FINAL DRAFT MINUTES

February 15, 2024, Standards Committee Meeting

RE: Minutes from the February 15, 2024, Standards Committee Meeting

STANDARD SPECIFICATIONS, SPECIAL PROVISIONS AND STANDARD DRAWINGS

E 801-TPAR series (proposed new, **revised draft**)

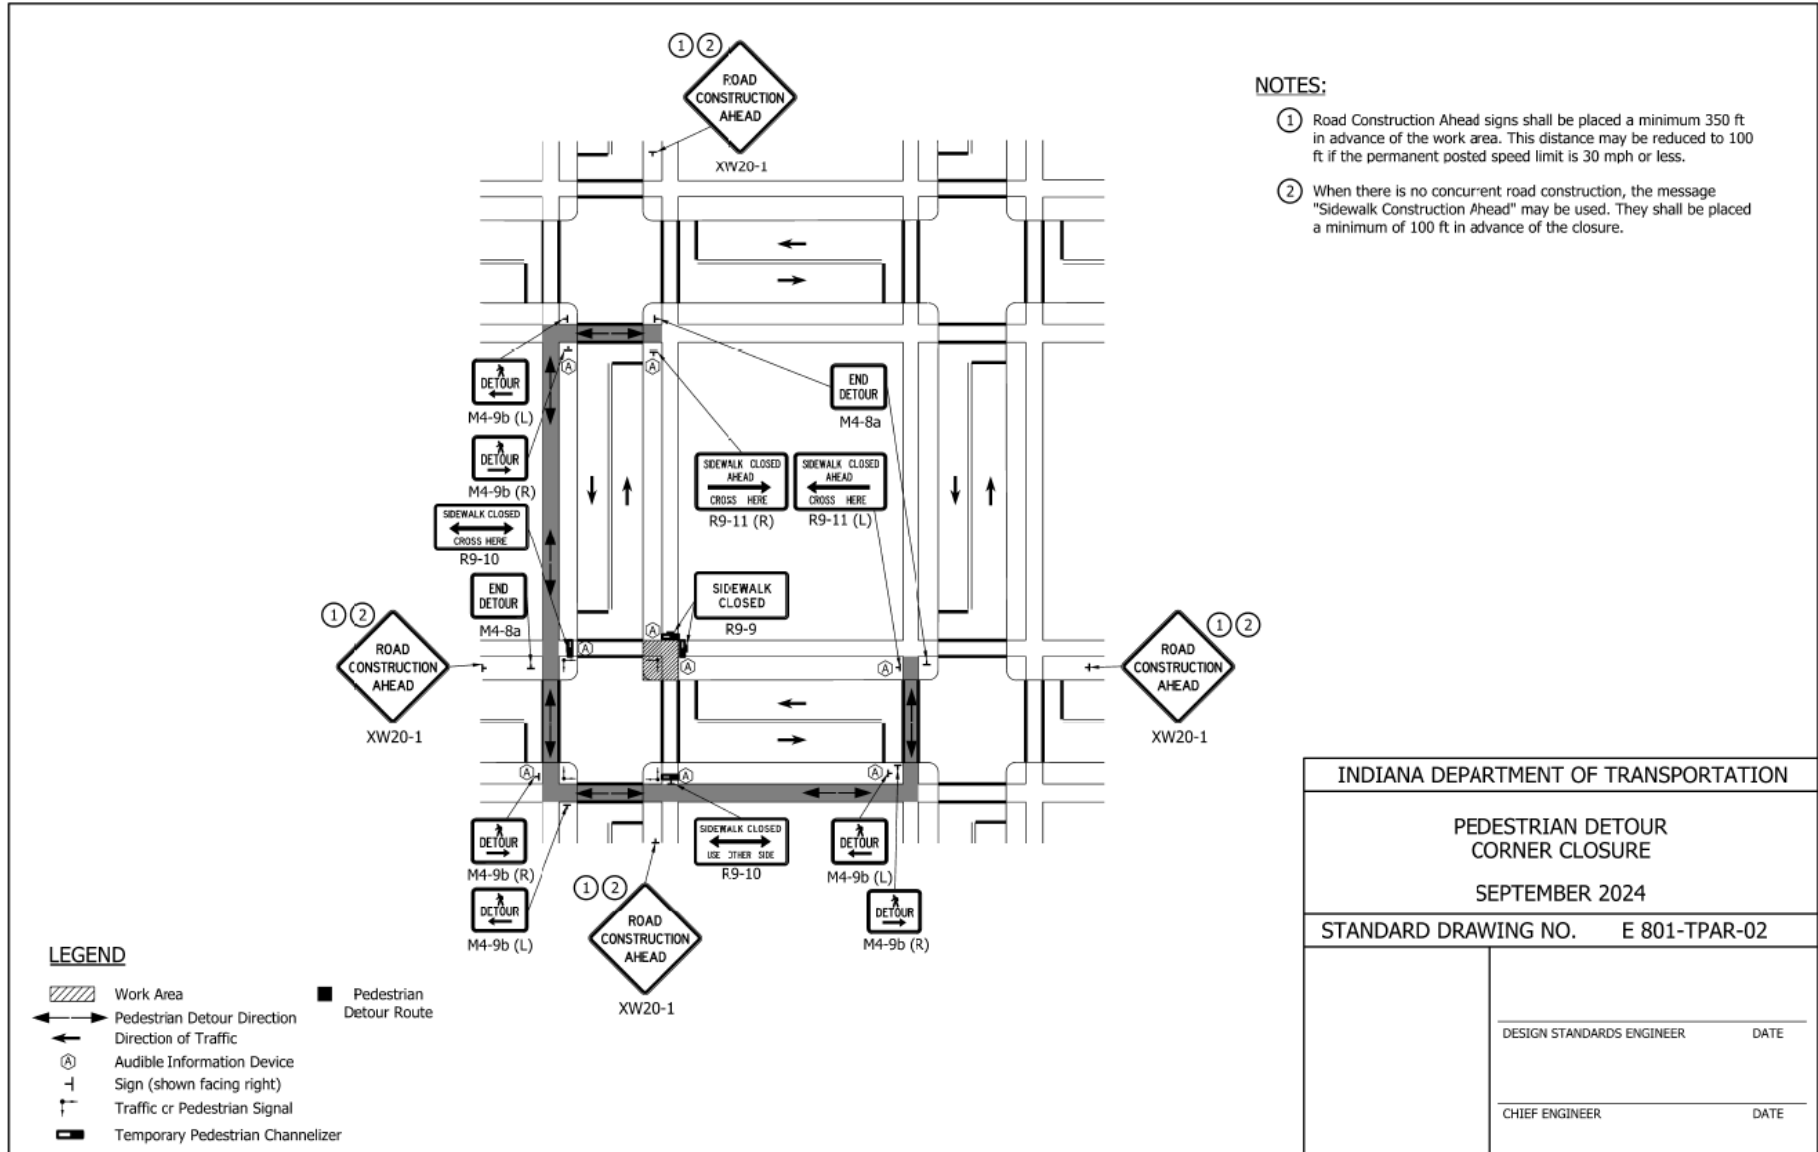
Mr. Laracuente suggested adding a note to the drawings that access to businesses and residences shall be maintained. Mr. Koch added that there is language in 107.08(e). Mr. Boruff asked Ms. Smutzer if language can be added to 107.08 for access. A small change will be made to the drawing E-801-TPAR-02 regarding the audible information devices that need to be shown, so Mr. Boruff revised his motion. Mr. Orton seconded the revised motion.

Note: Revised draft of the E 801-TRAP-02 is shown in these minutes.

INDIANA DEPARTMENT OF TRANSPORTATION	
TEMPORARY CURB RAMPS	
SEPTEMBER 2024	
STANDARD DRAWING NO.	E 801-TPAR-10
DESIGN STANDARDS ENGINEER	DATE
CHIEF ENGINEER	DATE

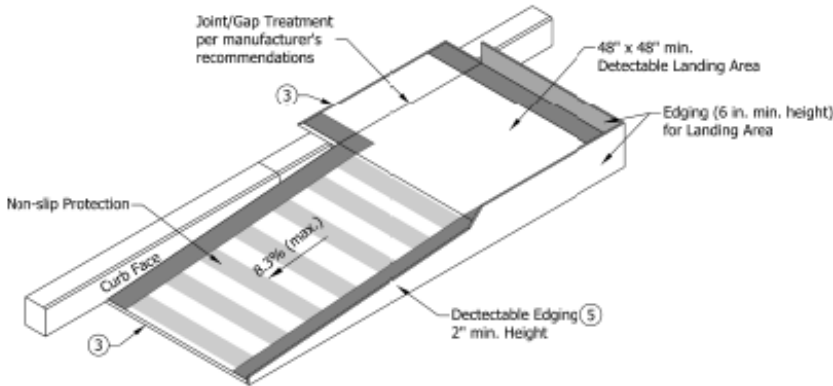
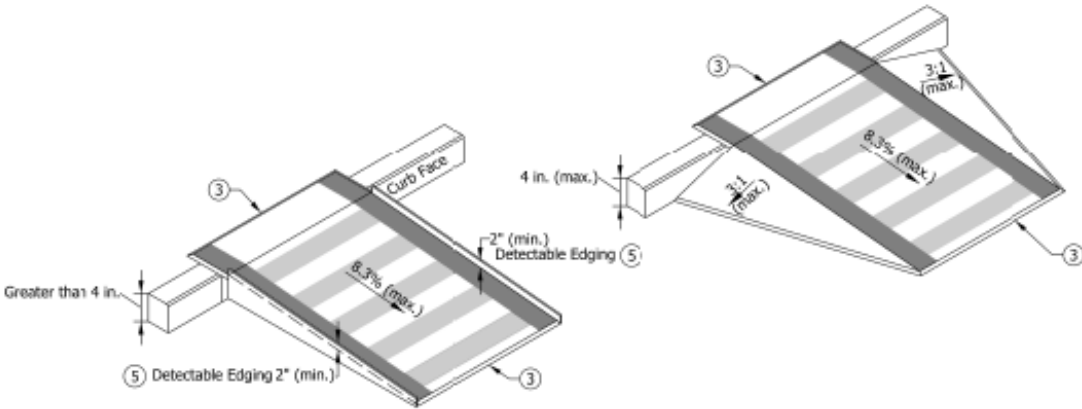
6. The rise of a single temporary curb ramp shall be no more than 30 in. If more than one temporary curb ramp is needed at a location due to the change in elevation, a minimum 5 ft landing area shall be used between curb ramps. The landing area shall have a slope of less than 2.0%.
